# Work Order ID 94675

**D3290-3 WINDOW**

DESIGN	<i>DF</i>	<b>DART AEROSPACE LTD</b>	
DRAWN	<i>DF</i>	HAWKESBURY, ONTARIO, CANADA	
CHECKED	<i>DF</i>	DRAWING NO.	REV. C
MFG. APPR.	<i>DF</i>	D3290	SHEET 2 OF 2
APPROVED	<i>DF</i>	TITLE	SCALE
DE APPR.	<i>DF</i>	REPLACEMENT WINDOW ASSEMBLY	1:5
DATE	07.07.24	<small>COPYRIGHT © 2004 BY DART AEROSPACE LTD THIS DOCUMENT IS PRIVATE AND CONFIDENTIAL AND IS SUPPLIED ON THE EXPRESS CONDITION THAT IT IS NOT TO BE USED FOR ANY PURPOSES OR COPIES OR COMMUNICATED TO ANY OTHER PERSON WITHOUT WRITTEN PERMISSION FROM DART AEROSPACE LTD.</small>

DRAWING NO. D3290	TITLE REPLACEMENT WINDOW ASSEMBLY	REV. C	DART AEROSPACE LTD ENGINEERING ORDER		D.E.O. NO. D3290-C-1	SHEET NO. SHEET 1 OF 1	SCALE NTS
DRAWN <i>q</i>	CHECKED <i>h</i>	MFG. APPR. <i>E</i>	APPROVED <i>MP</i>		DE APPR. <i>h</i>		
DATE 09.09.18	DATE 09.09.18	DATE 09.09.18	DATE 09/09/21		DATE 09/09/21

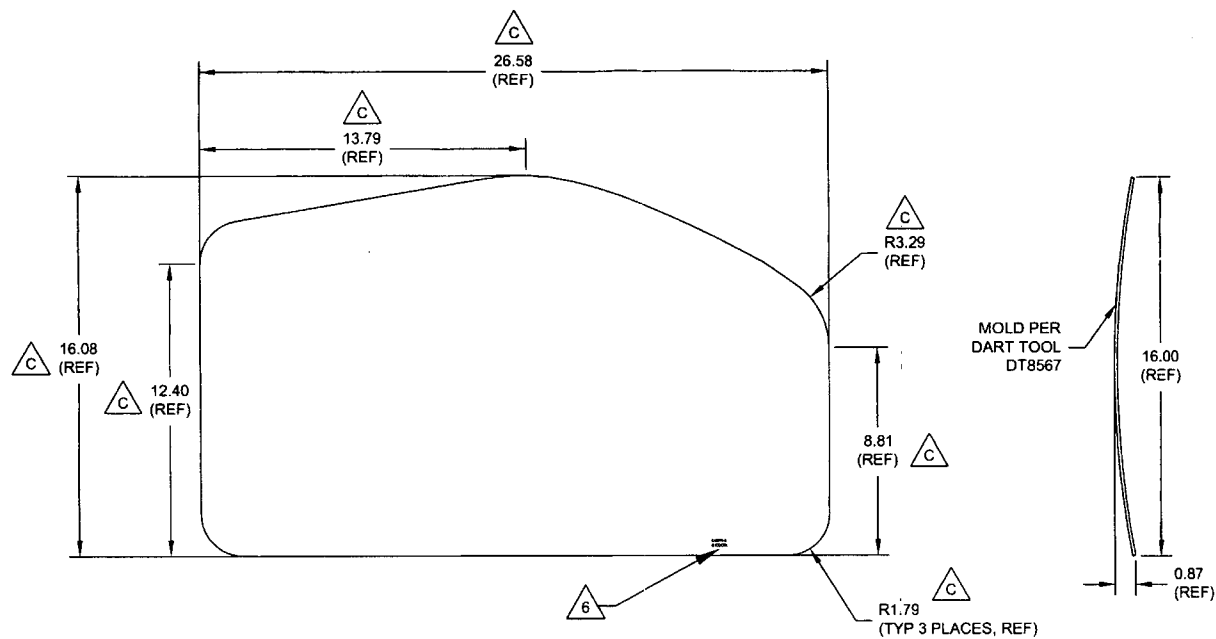
**PURPOSE:**

CHANGE MATERIAL THICKNESS OF D3290-1 FRAME TO 0.063 FROM 0.040. REF PAR 09-033.

**CHANGE:**

MATERIAL CALL-OUT OF D3290-1 FRAME ON SHEET 1 IS AMENDED AS FOLLOWS:

- 1) MATERIAL: 6061-T6 (OR 6061-T62) ALUMINUM SHEET ~~0.040 THICK~~ 0.063 THICK (REPLACE)  
 PER AMS-QQ-A-250/11 OR AMS 4025 OR AMS 4027  
~~(REF. DART SPEC. M6061T6S.040)~~ REF. DART SPEC. M6061T6S.063 (REPLACE)  
 OR  
 5052-H32 ALUMINUM SHEET ~~0.040 THICK~~ 0.063 THICK (REPLACE)  
 PER AMS-QQ-A-250/8 OR AMS 4016  
~~(REF. DART SPEC. M5052H32S.040)~~ REF. DART SPEC. M5052H32S.063 (REPLACE)
